THREE MILE ISLAND NUCLEAR STATION, UNIT NO. 1

AMENDMENT TO FACILITY OPERATING LICENSE

Amendment No. 38
License No. DPR-50

ATTACHMENT TO LICENSE AMENDMENT NO. 38

Figure 3.5-2I

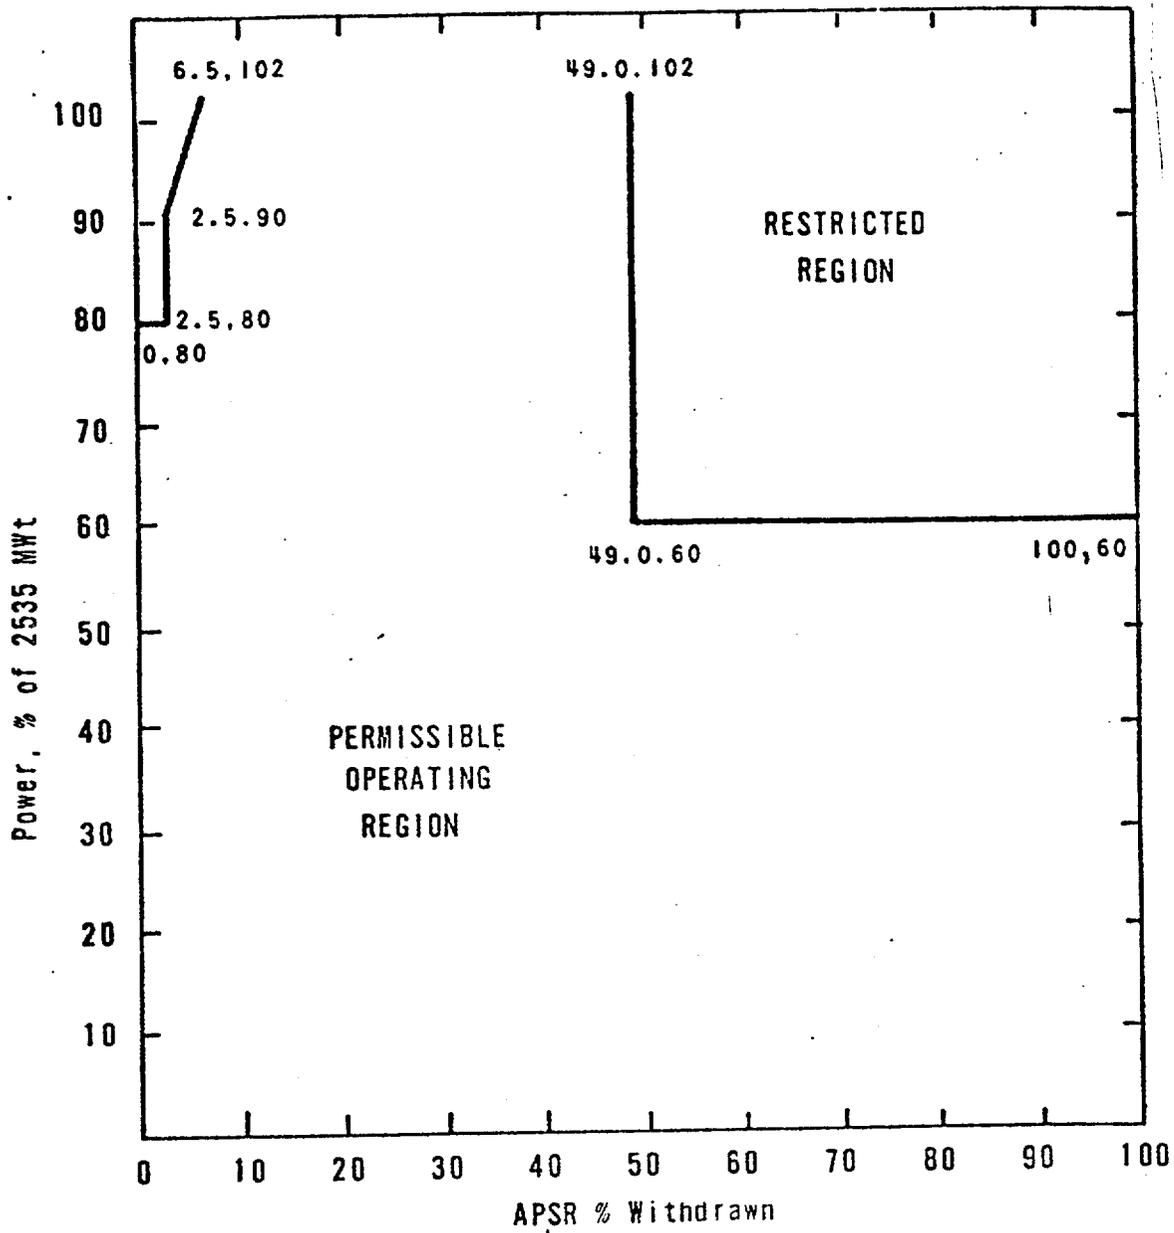
<u>Remove Pages</u>	<u>Insert Pages</u>
vii	vii
3-34a	3-34a
3-35	3-35
3-35a	3-35a
Fig. 3.5-2I	Fig. 3.5-2I
Fig. 3.5-2M	Fig. 3.5-2M
-	Fig. 3.5-2N

<u>Figure</u>	<u>Title</u>
3.5-2H	Operational Power Imbalance Envelope Applicable to Operation from 100+ 10 to 246+ 10 EFPD; Cycle 3
3.5-2I	Operational Power Imbalance Envelope Applicable to Operation from 246+ 10 EFPD to 315 EFPD; Cycle 3

3. The operational imbalance limits (Figure 3.5-2G, 3.5-2H and 3.5-2I) shall be reduced 2 percent in power for each 1 percent tilt in excess of the tilt limit.

OPERATIONAL POWER, IMBALANCE ENVELOPE
FOR OPERATION FROM 246 ± 10 EFPD TO 315 EFPD
TMI-1 CYCLE 3

Figure 3.5-2M

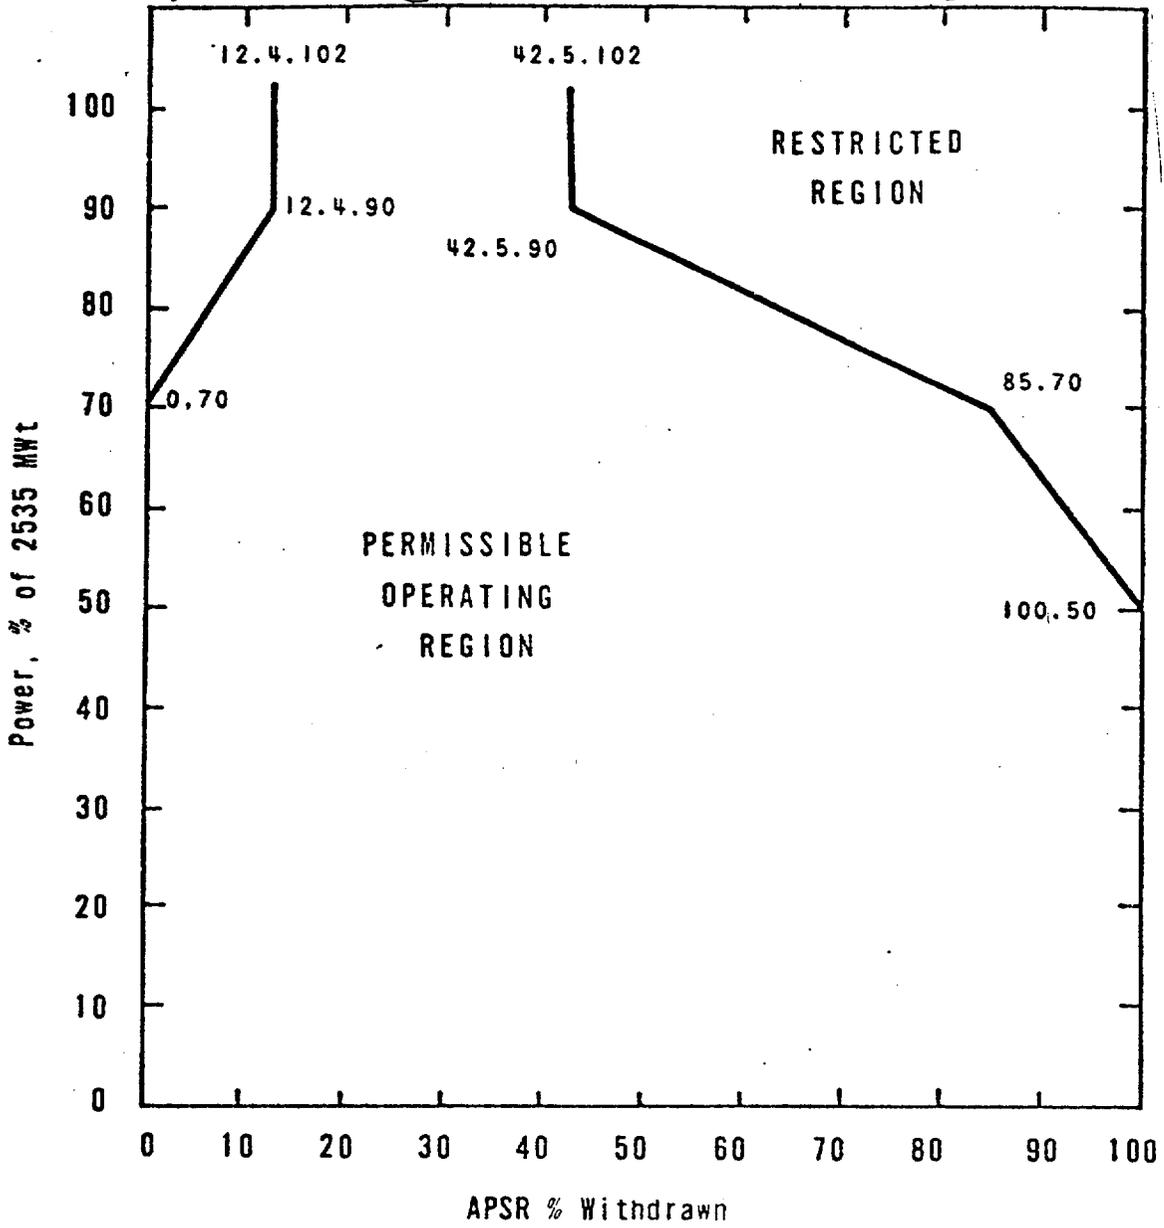
3.5-2M	APSR Position Limits for Operation from 246+ 10 EFPD to 270+ 10 EFPD; Cycle 3
3.5-2N	APSR Position Limits for Operation from 270+ 10 EFPD to 315 EFPD; Cycle 3

2. The control rod group withdrawal limits (Figures 3.5-2A, 3.5-2B, 3.5-2C, 3.5-2D, 3.5-2E, 3.5-2F, 3.5-2K, 3.5-2L, 3.5-2M, and 3.5-2N) shall be reduced 2 percent in power for each 1 percent tilt in excess of the tilt limit.

APSR POSITION LIMITS FOR OPERATION
 FROM 246 ± 10 EFPD TO 270 ± 10 EFPD
 TMI-1 CYCLE 3
